ADDENDUM NO. 4

TO THE DRAWINGS AND SPECIFICATIONS
FOR THE
Burgin Independent School Addition & Renovation
Burgin, Kentucky
RTA 1904
BG 19-262
October 30, 2019

FIRST FLOOR PLAN - FLOOR PATTERN
1/8" = 1'-0"

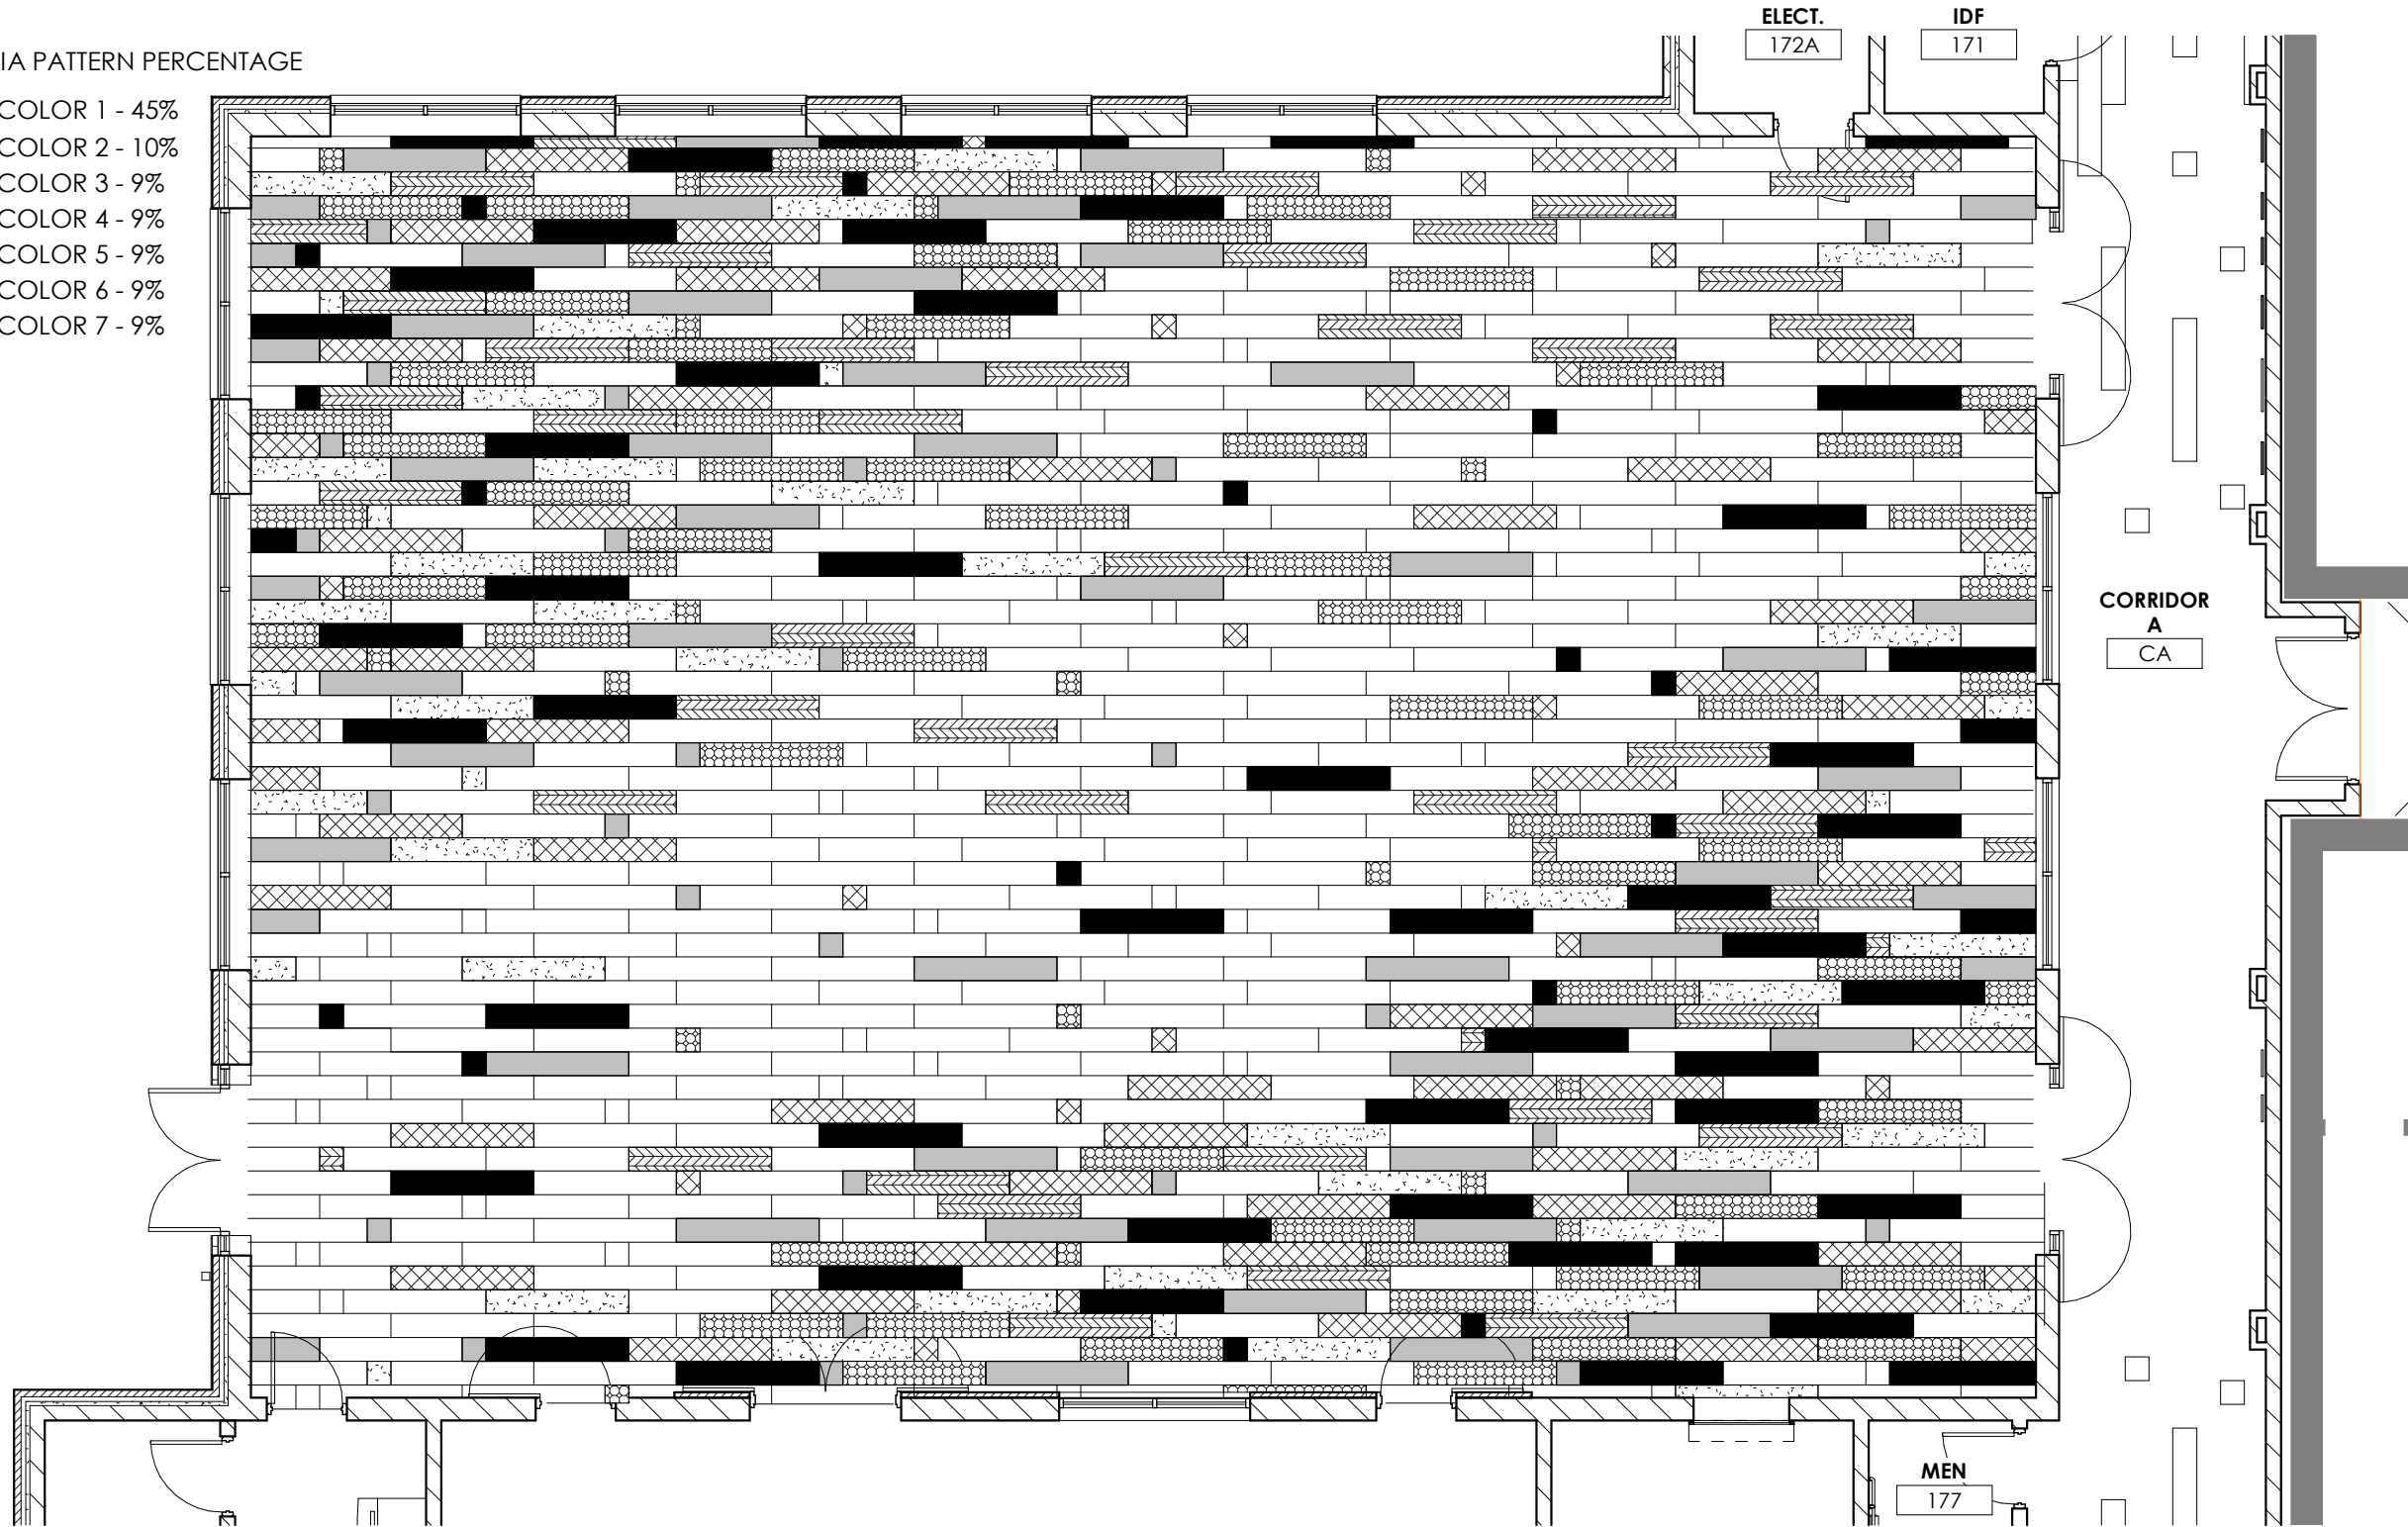
1. **Refer to sheet A2.1 Floor Plans - Interior:**
 - a) Insert attached sheet AD4.1 for additional information concerning the floor pattern. Estimated percentages are noted for the cafeteria and the pattern and color division will be similar in the adjacent hallway. Once color has been selected with the owner, a color coded pattern can be provided.
2. **Refer to sheet A6.1 Doors and Frame Schedule:**
 - a) Refer to the Schedule of Doors and Frames – Alternates #1 and #2:
 - i) Add the following Comment for Door B104:
 - a) Paint existing frame.
